Core Bus Corridor 5: Blanchardstown

16th December 2020

Figure 1 Improved Junction Design Blakestown and Blanchardstown Shopping Centre

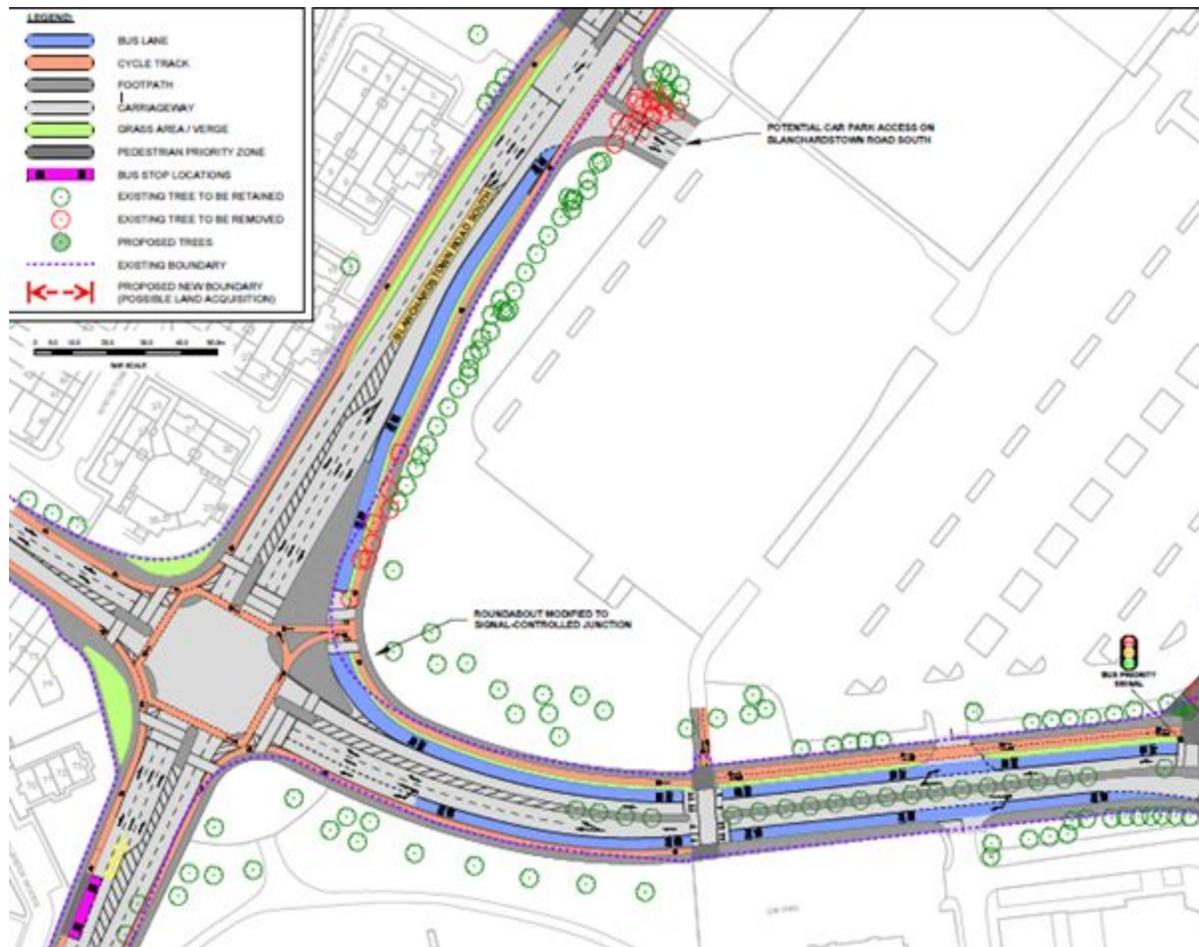
The updated design of the Blakestown Junction (Figure 1) to accommodate more cycling movements in all directions is a welcome improvement over the previous

designs. Removing the cycling hostile roundabout and implementing a segregated design approach dramatically increases the usability and safety for cyclists at this junction.

Figure 2 Reduction in Shared Space at Cabra Garda Station

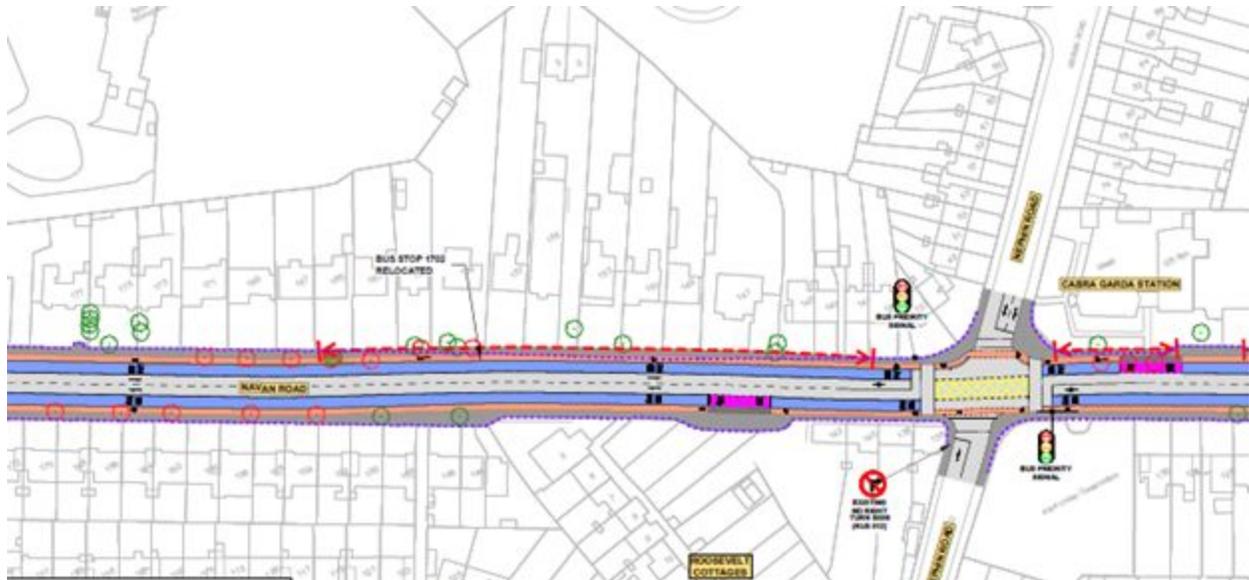
The reduction of shared space between pedestrians and cyclists at the junction at Cabra Garda Station (Figure 2) is a substantial improvement over the previous iteration.

Removing shared space between pedestrians and cyclists is recommended in the NCM Section 1.9.3. It is encouraging to see the designers endeavour to provide as much segregation as possible for pedestrians and cyclists. Furthermore, the increased segregation enables a “bus stop by-pass” at Roosevelt Cottages.

Figure 4 Illustrating Slip Lanes (Southern Portion of Blanchardstown Road Junction) Cutting Across Cycle Lanes Against National Cycling Manual Recommendations.

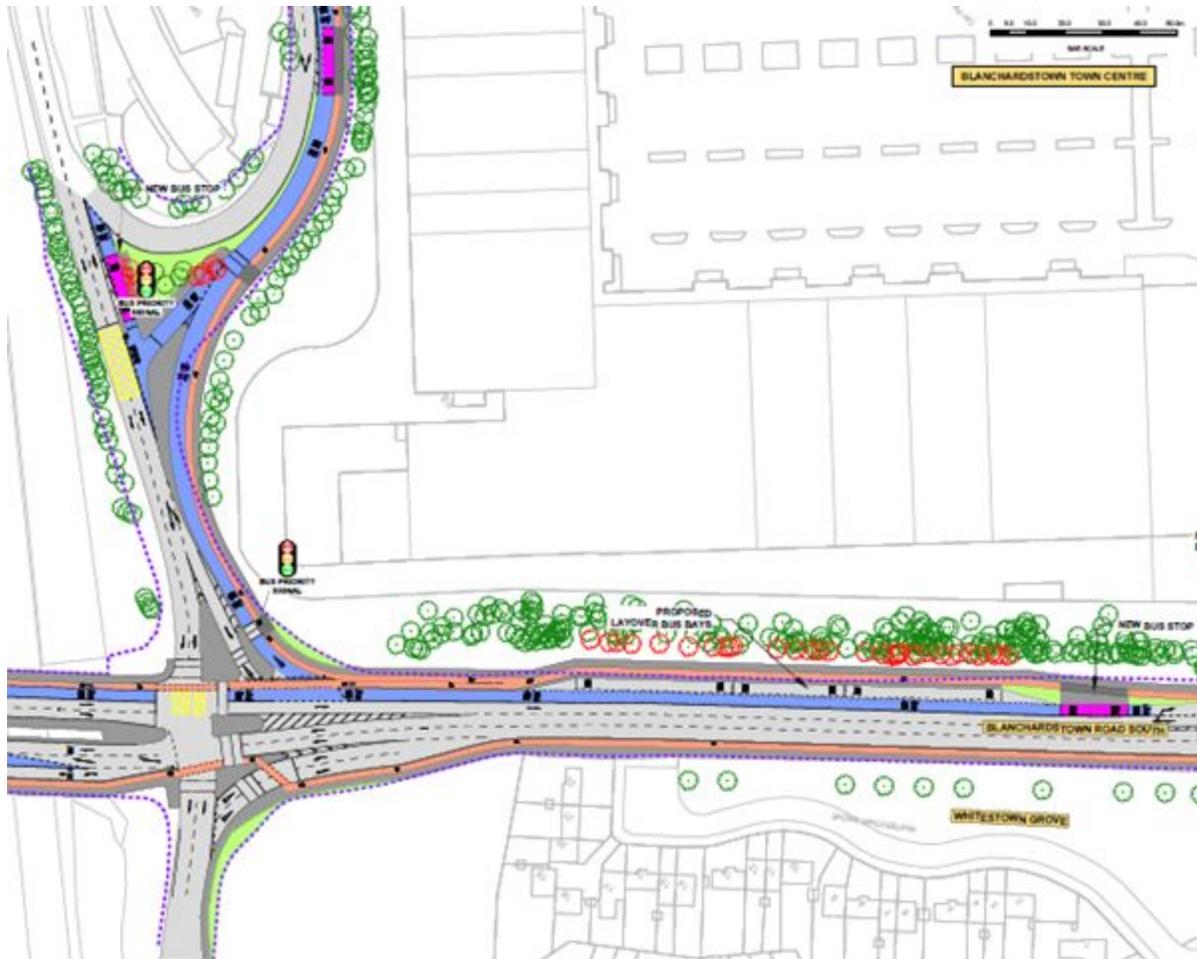
Providing cycle lanes across slip lanes is not recommended by the NTA's National Cycle Manual (section 4.4.4). These slip lanes should be removed (DMURS 4.4.3) or converted into pocket turns where complete slip lane removal isn't possible. Furthermore, these slip lanes increase crossing movements for both cyclists and pedestrians. A pedestrian wishing to cross from one side of the Blanchardstown road south, Figure 4, to the other; is forced to make five crossing movements. This clearly does not meet the objective detailed in Section 3.2 of the Transport Modelling Report:

Figure 5 Future Entrance to Edmund Rice Post Primary School (Navan Road Overpass at the Phoenix Park Racecourse)

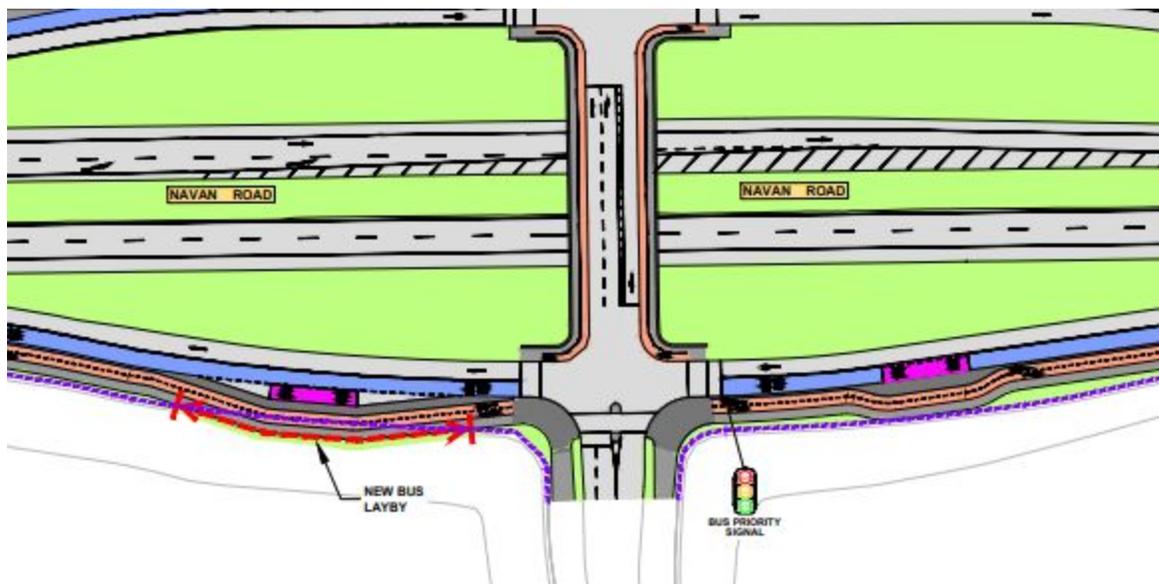
Significant shared space with pedestrians here, contradicting NCM Section 1.9.3. This junction will become the entrance to the new Edmund Rice Post-Primary school due to be completed in 2021. Consequently, cycle facilities should be kept separate from pedestrian movements and this junction should be upgraded to accommodate a 1,000 student school. Cycle and pedestrian facilities should be prioritised and segregated in accordance with the Transport Modelling Report and NCM guidelines respectively.

There should be cycle facilities designed to integrate with any cycling facilities resulting from the school's construction. A "raised entry treatment" should be strongly considered for this crossing to assert that pedestrians and cyclists do in fact have priority.

Figure 6 Entrance to Phoenix Park Avenue, Navan Road

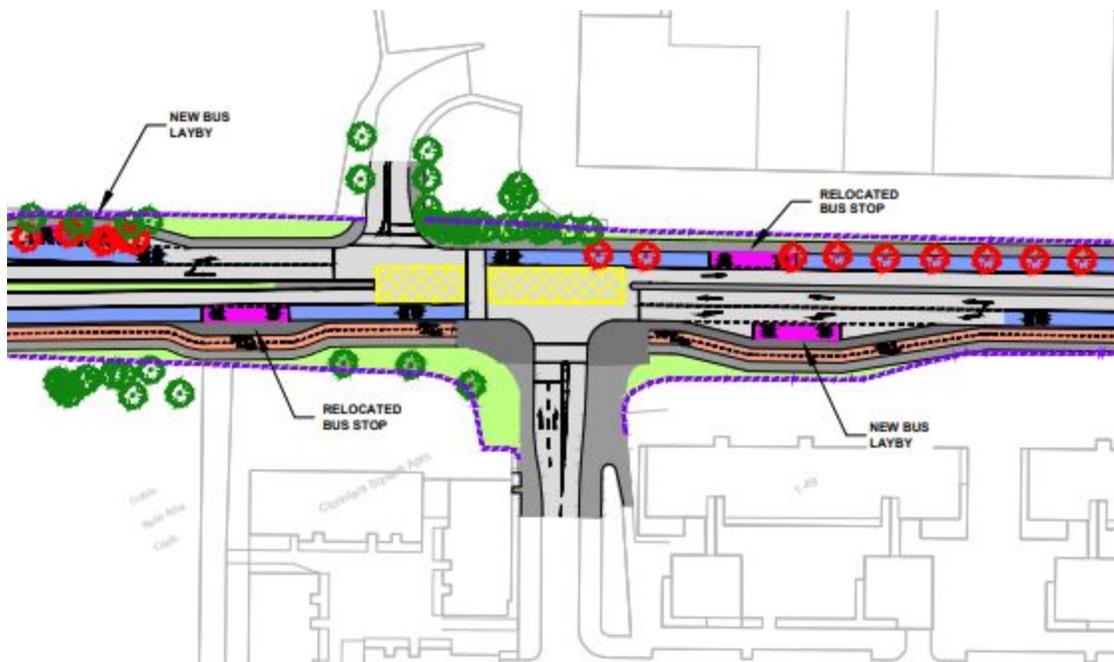
Cycle and pedestrian facilities should be prioritised and segregated in accordance with the Transport Modelling Report and NCM guidelines respectively. A "raised entry treatment" should be strongly considered for this crossing to assert that pedestrians and cyclists do in fact have priority.

Figure 13 Schematic Illustrating Width of Queen Street using ImageJ Software Analysis

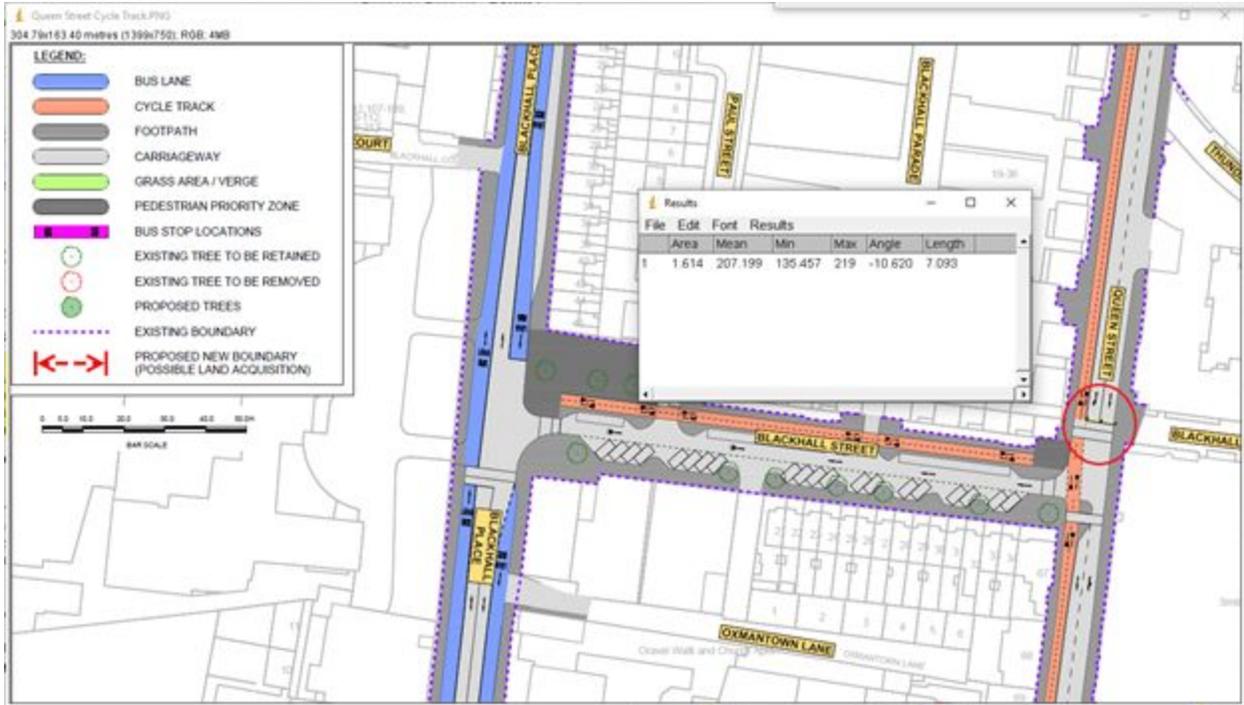
The 2.8m (Figure 14) bufferless bidirectional cycle track proposed for Queen Street is too narrow, particularly at junctions. The widths were measured using ImageJ Software Analysis (Rasband, W.S., ImageJ, U. S. National Institutes of Health, Bethesda, Maryland, USA, <https://imagej.nih.gov/ij/>, 1997-2018.) Figure 13 shows that the road width for motor vehicles on Queen St is 7m. This equates to two 3.5m vehicle lanes on a street that is supposed to prioritise the movement of people rather than vehicles (Section 3.2 Transport Modelling Report).

An alternative option would be to reduce the number of traffic lanes from 3.5m to 2.8-3m each. Queen Street is a 30km/h road with only one traffic calming measure (kerb build-out after Blackhall Place Junction). Reducing the traffic lane width would provide consistent traffic calming along the entire route. The extra 50-90cm should be used to widen the cycle track and install a buffer. Furthermore, cycle lanes will be provided on Liam Mellows Bridge to link Queen St and Bridgefoot St. Consequently, there will only be sufficient space for one traffic lane. Heuston Station bound traffic will be required to be diverted down Blackhall St to cross the river Liffey at James Joyce Bridge.

Figure 14 Schematic Illustrating Width of Cycle Track on Queen Street using ImageJ Software Analysis

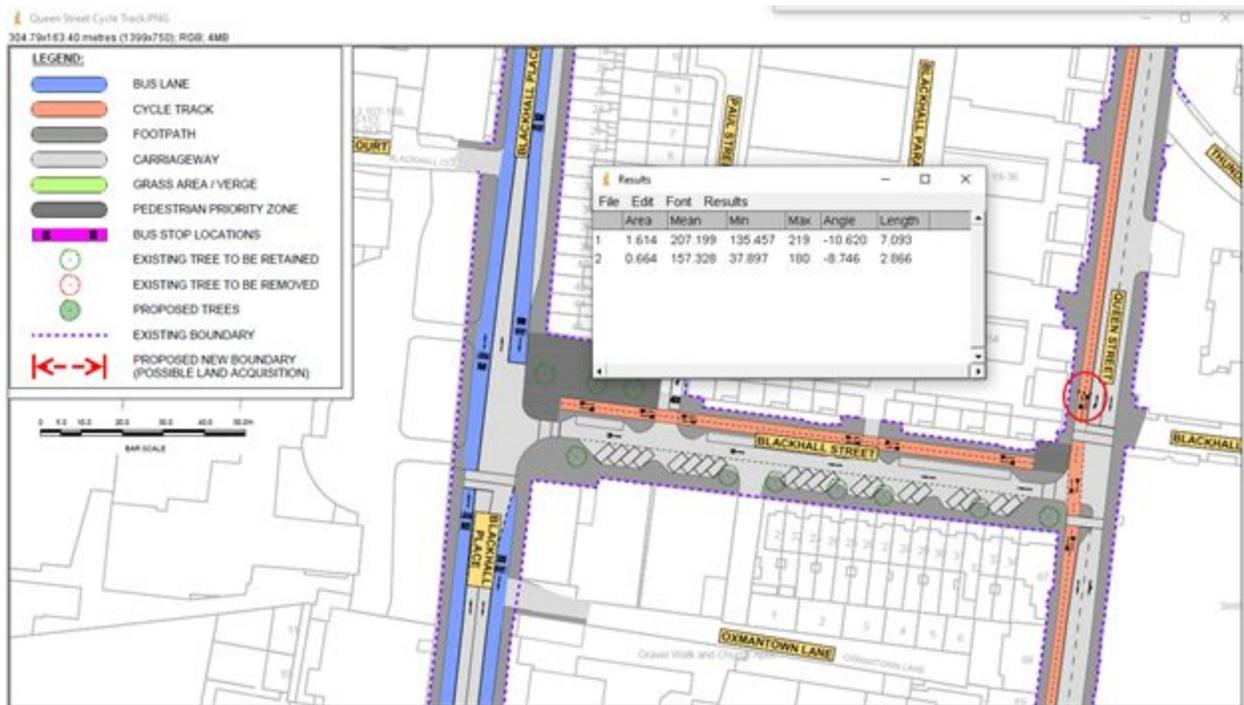
That measure will remove nearly half the traffic on Queen St beyond the Blackhall St junction. Consequently, an entire traffic lane for the relatively small number of vehicles that turn left onto the Quays is not an efficient use of that public space. Secondly, there is a missing crossing / shared space at the junction of Blackhall Street / Blackhall Place (Figure 14). This absence can be easily resolved in future iterations.
